7H.P. Front Cover for Tunnel

7-HP.

FLOOR BOARDS

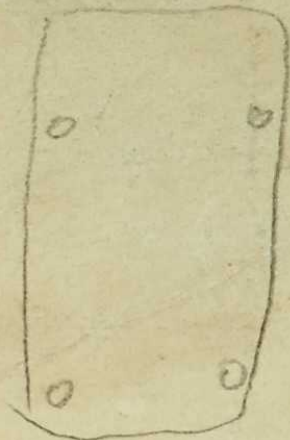
7HP. "VJ" Rear Floors - Modified to improve interior finish.

Commence on Body No; 1013.
